OUTCOME OF TRO PROCESS

TITLE OF REPORT: Upper Bristol Road, Bath

PROPOSAL: Active Travel Fund Scheme
(i) Road humps (part of continuous footways)
(ii) Parking & loading restrictions
(iii) Mandatory cycle lanes
(iv) Pedestrian crossing
(v) 20mph speed limit

SCHEME REF No: 21-015, 21-015A, 21-015B, 21-015C, 21-015D, 21-015E**REPORT AUTHOR: Paul Garrod****1. DELEGATION**

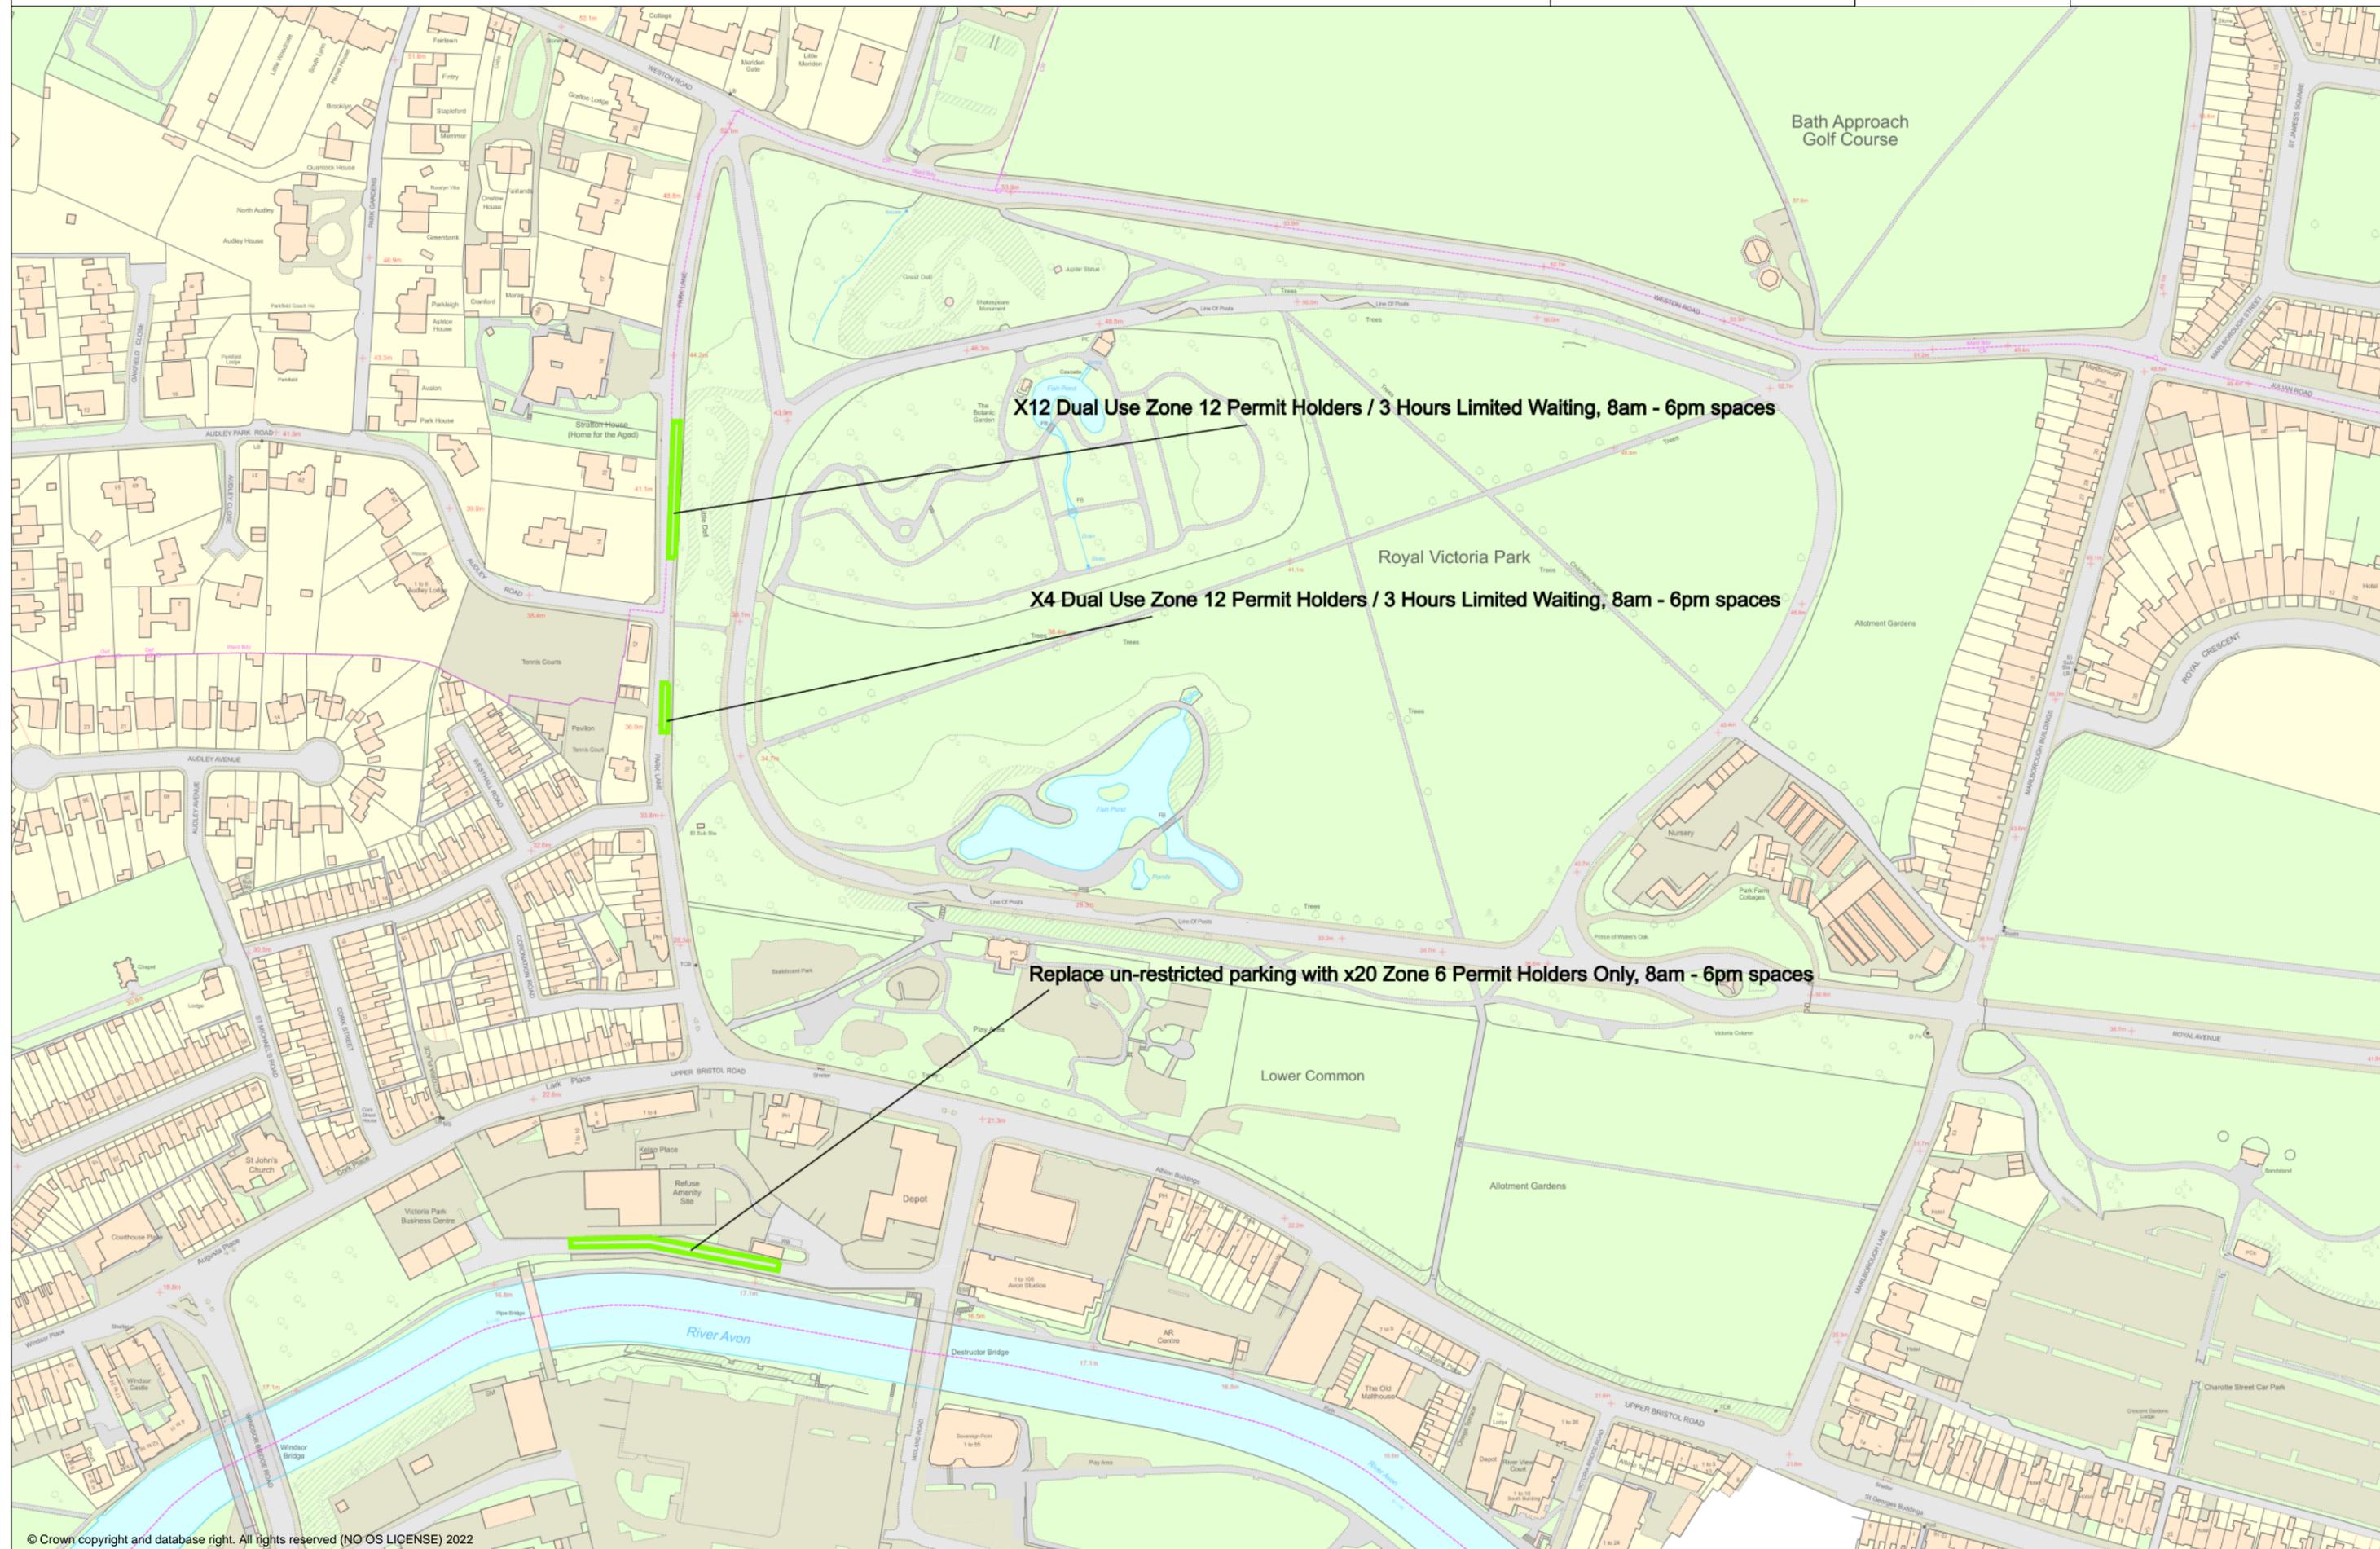
These three objections were from residents living in Park Lane. Two were concerned that removing some of the existing yellow lines in order to create new parking spaces would lead to larger vehicles such as buses not being able to get through and also cause difficulties for access to/from a private driveway. The other was concerned that the proposals would make it more difficult for residents to park. One stated they support the Upper Bristol Road scheme but have given an objection response to the consultation due to the changes proposed to Park Lane.

Response: the proposed parking restriction changes in Park Lane have been reviewed following these comments about potential obstruction. To reduce the risk of this happening amended proposals which retain most existing double yellow lines are recommended and that the proposed shared use permit holder/three hour parking bay north of the Audley Park Road junction is extended so there is the same overall number of spaces within the bays as originally proposed. The updated drawing is shown in Appendix 2.

The proposal to remove existing no waiting at any time (double yellow line) restrictions in Park Lane is reduced in extent in order to prevent obstruction to traffic and access to a driveway, and the proposed shared use Zone 12 / 3 hour parking bay is extended north as shown in the drawing in Appendix 2.	
--	-------------------------------------------------------------------------------------------------------------------------------------------------------------------------------------------------------------------------------------------------------------------------------------------------------------------	--
